ADDENDUM NO. 3
June 6, 2023

2023 RECONSTRUCT TERMINAL BUILDING
AIP No. 3-27-0025-20-2023
SKY HARBOR AIRPORT
DULUTH, MN

This addendum consists of 2 pages and Drawing Nos. G2.10, C3.00, C4.00, C5.01, A301, S101, S502, and S504.

REVISION SCHEDULE		
REV. #	DESCRIPTION	DATE
△1	ADDENDUM #1	5/30/2023
△2	ADDENDUM #2	6/2/2023
△3	ADDENDUM #3	6/6/2023

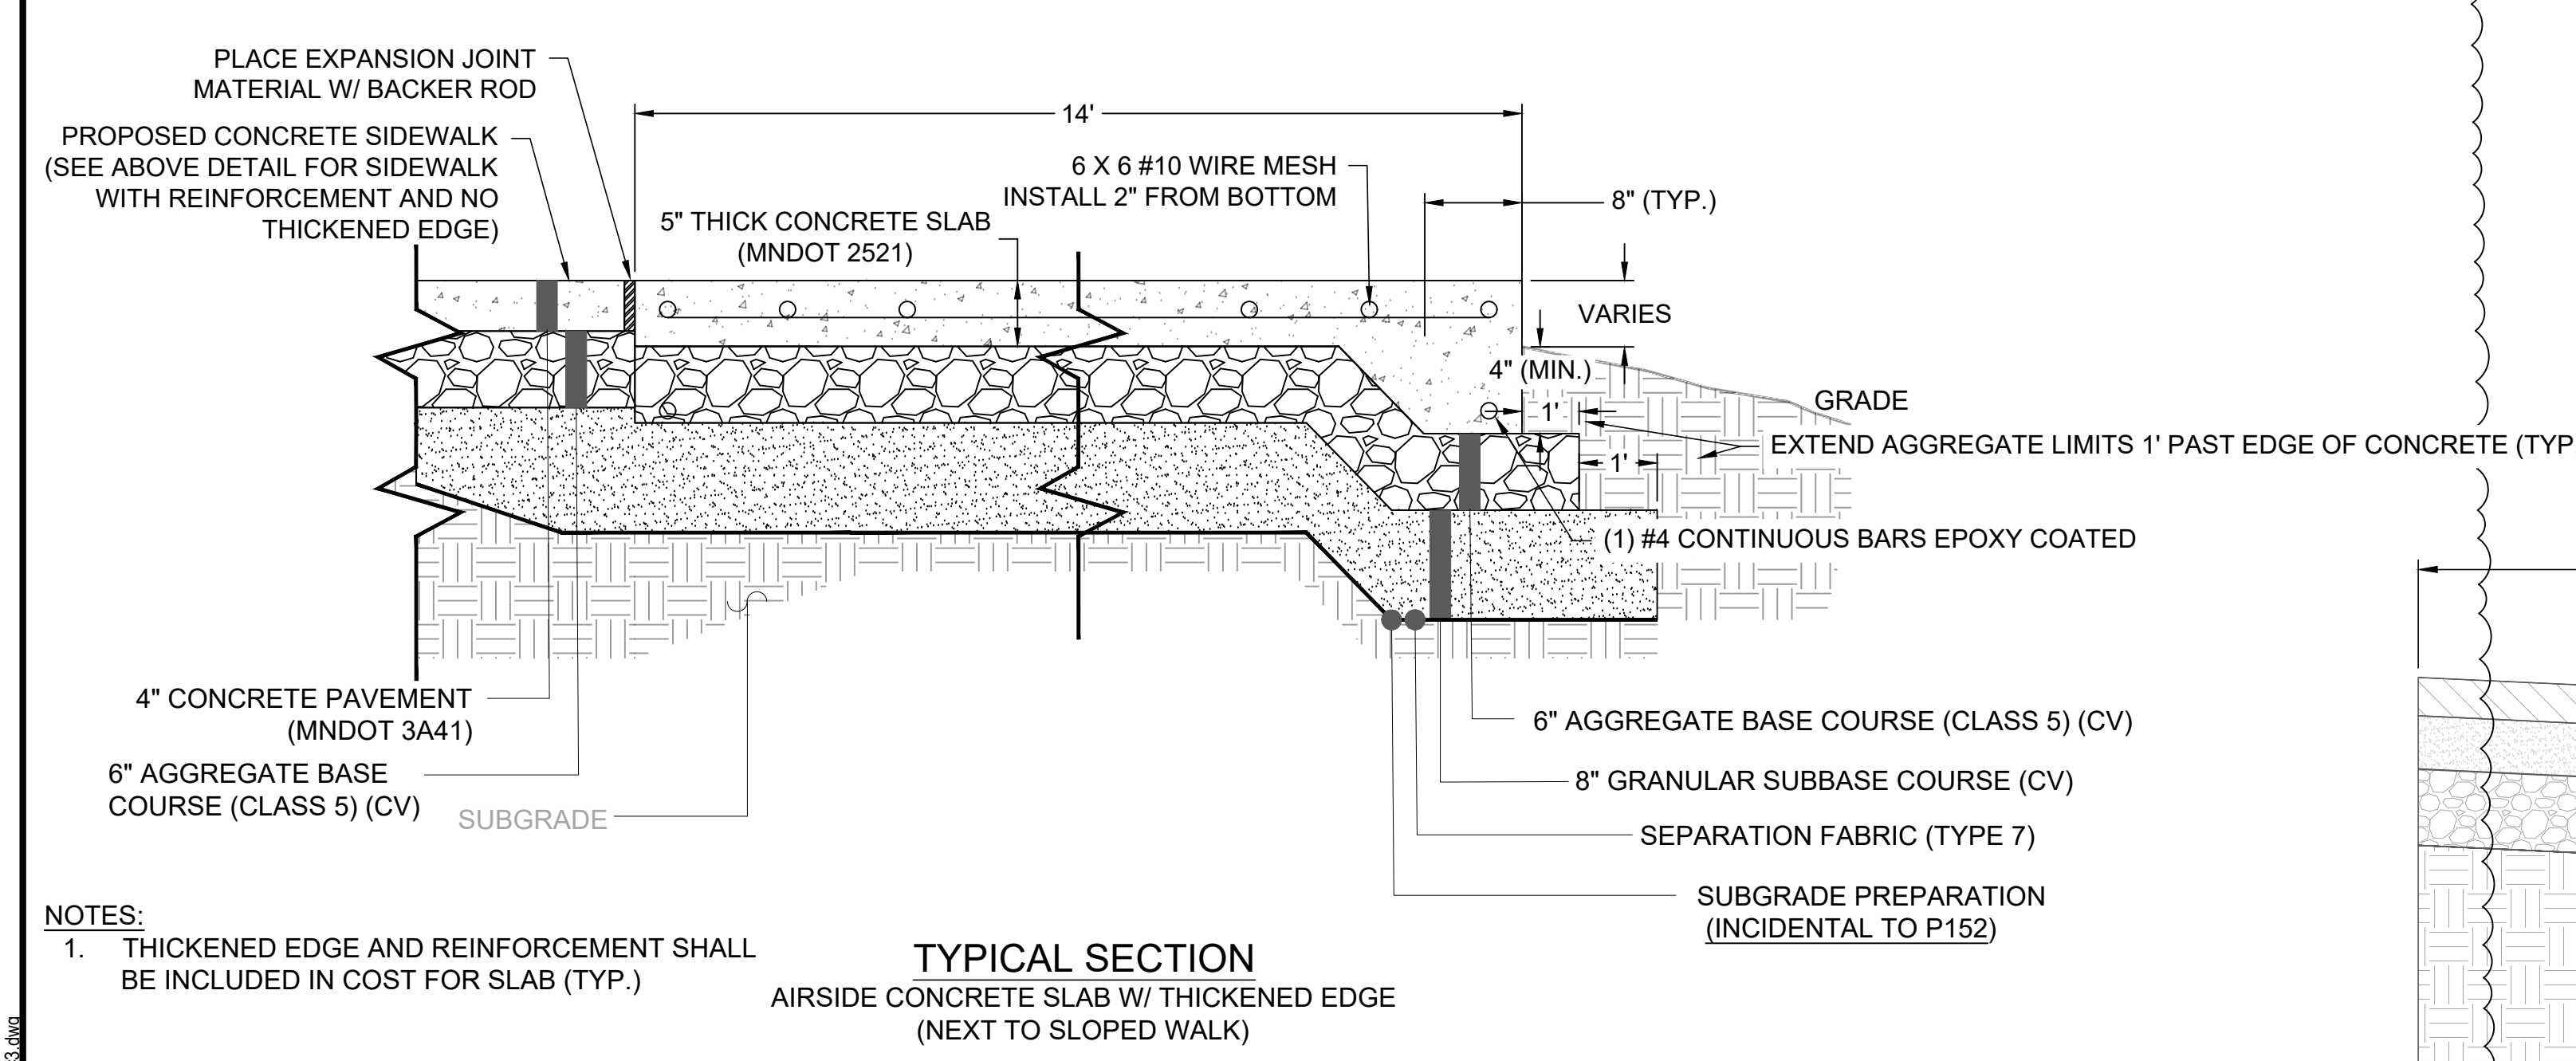
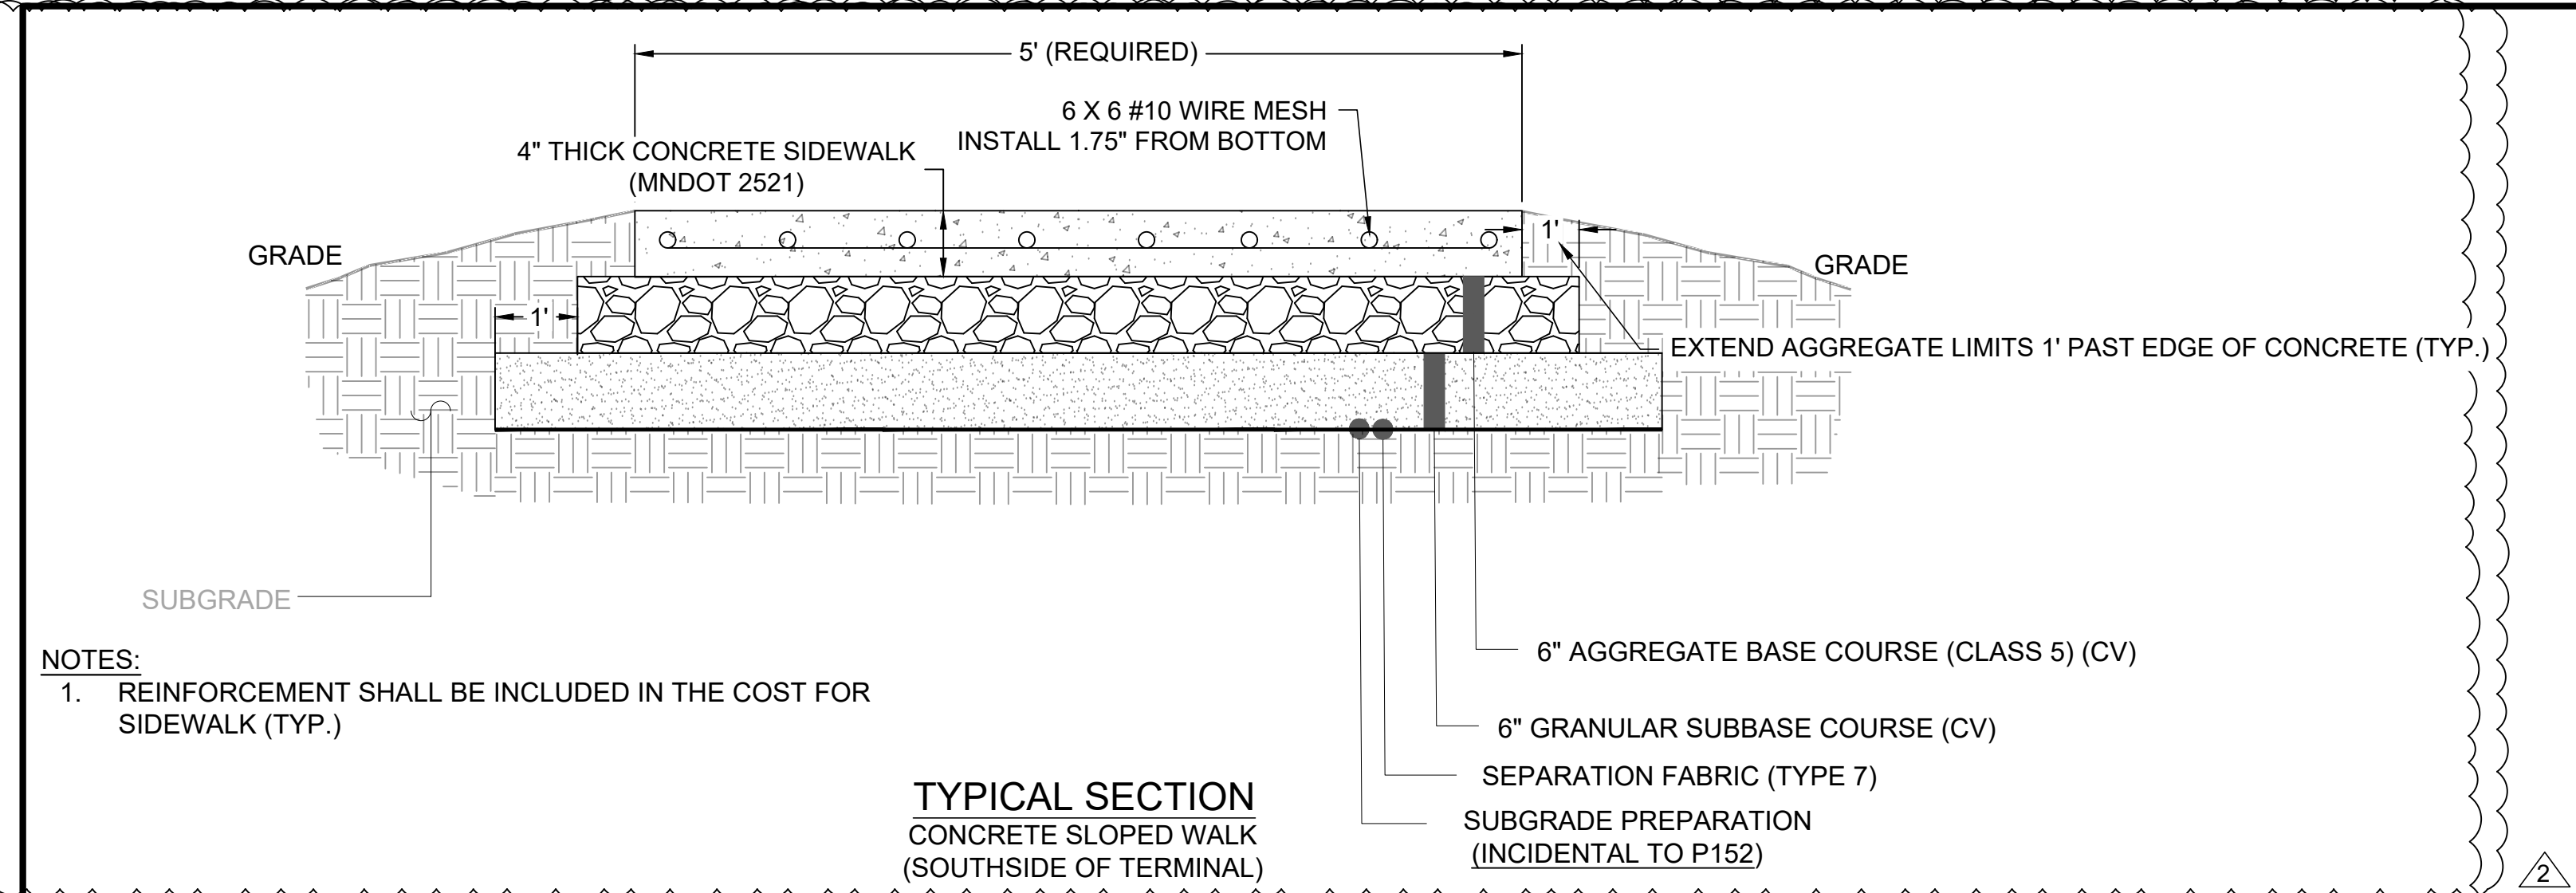
1. Drawing G2.10 – Statement of Quantities, DELETE in its entirety and REPLACE with the attached revised drawing.
 - Updated Quantities and Quantity Notes related to Item No. 39.

- Quantities changed related to Item No.39, for shifting northside sloped walk to structural discipline and shall be covered under Item No. 59.
2. Drawing C3.00 – Typical Sections, Drawing C4.00 – Pavement Plan, DELETE in its entirety and REPLACE with the attached revised drawing.

PAVEMENT PLAN

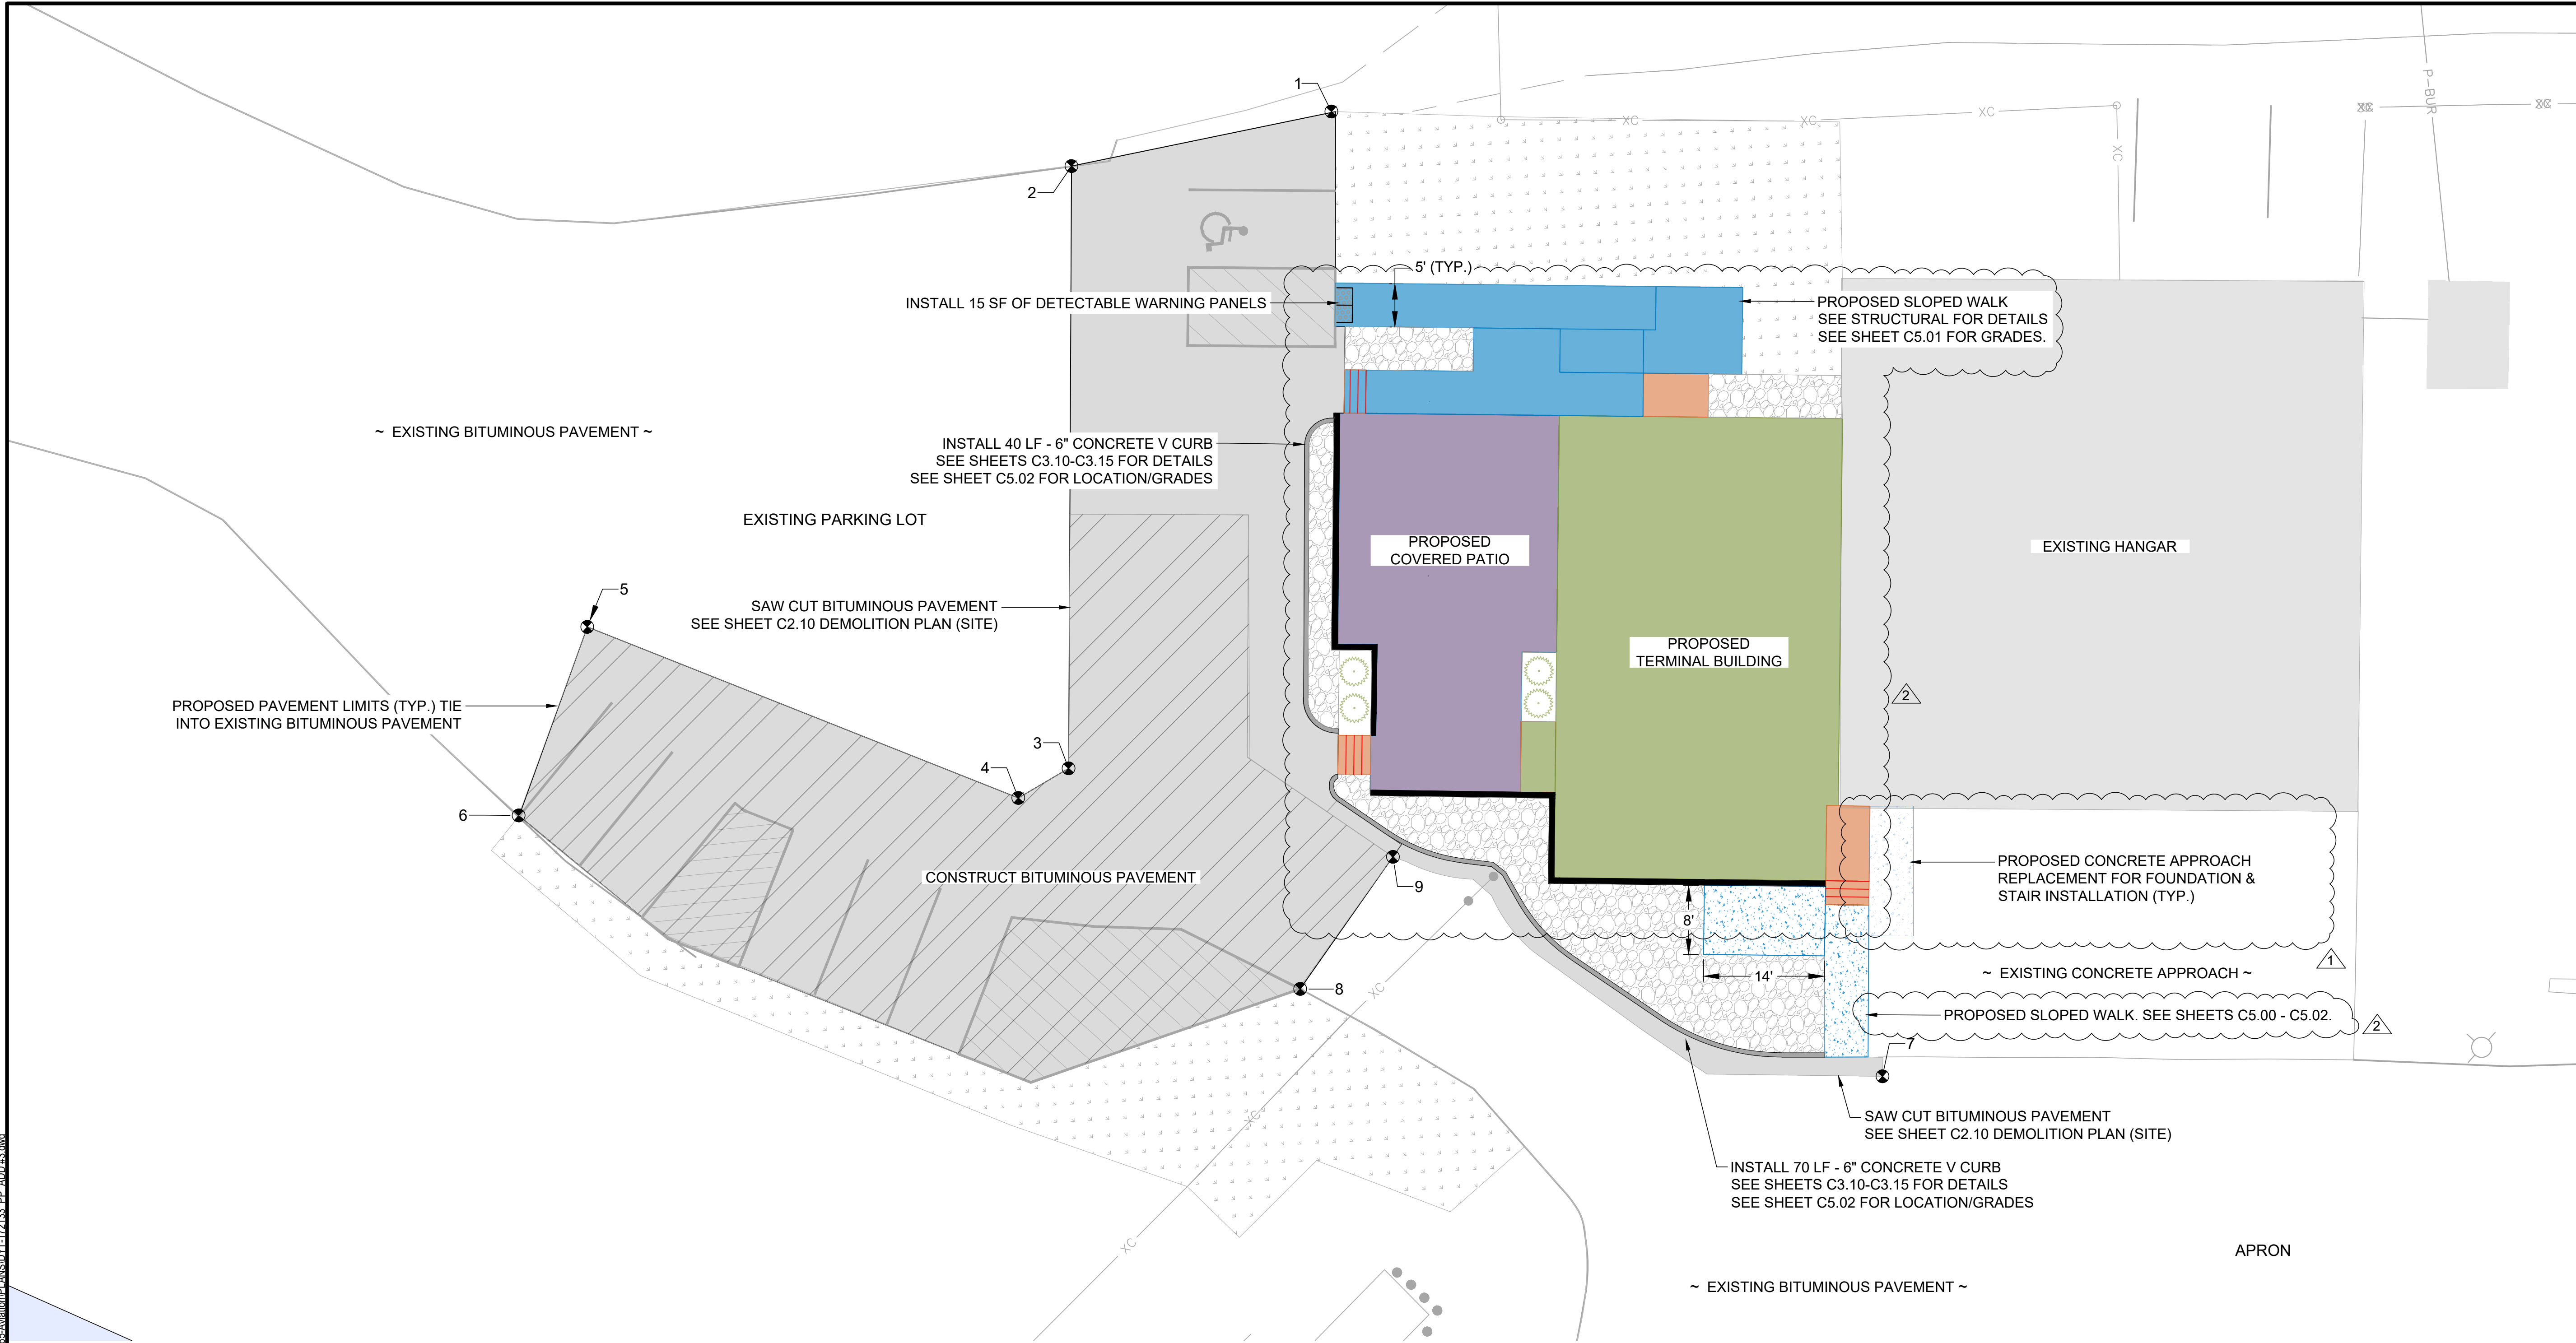
- Updated typical section for sloped sidewalk.
3. Drawing C4.00 – Pavement Plan, DELETE in its entirety and REPLACE with the attached revised drawing.
 - Revised pavement plan limits for concrete sloped walk, related to structural drawings. Northside sloped walk will be covered under structural and building construction item.
